TO:	CHAIR AND MEMBERS LONDON ADVISORY COMMITTEE ON HERITAGE MEETING ON WEDNESDAY OCTOBER 12, 2016
FROM:	JOHN M. FLEMING MANAGING DIRECTOR, PLANNING AND CITY PLANNER
SUBJECT:	HERITAGE ALTERATION PERMIT APPLICATION AT 40 BYRON AVENUE E., WORTLEY VILLAGE-OLD SOUTH HCD BY: M. EL-HOURANI

That, on the recommendation of the Managing Director, Planning & City Planner, with the advice of the Heritage Planner, the application under section 42 of the *Ontario Heritage Act* to partially rebuild the lower front porch of the building located at 40 Byron Avenue East, within the Wortley Village-Old South Heritage Conservation District, **BE PERMITTED** as described in this application (along with attached drawing) with the following terms and conditions:

Image 5: Porch detail of post, rail and steps

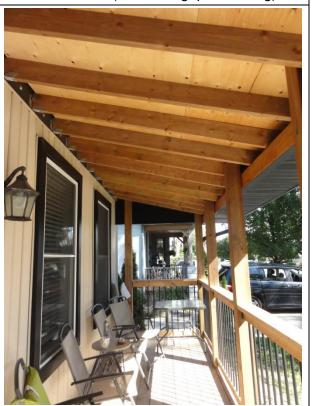
- replace the existing poured concrete stoop with an open, covered porch constructed of pressured treated lumber.
  - The porch balustrade is constructed of pressure treated posts with aluminium balusters capped with pressure treated handrails [Appendix B, image 2].

- is in keeping with the neighbourhood context with respect to overall form and massing, although it is articulated in non-historical materials and detailing [Appendix B, image 7].
- does not contribute, nor does it take away from the architectural character of the area.

a) That all exposed wood be painted within (9) months of date of heritage approval.
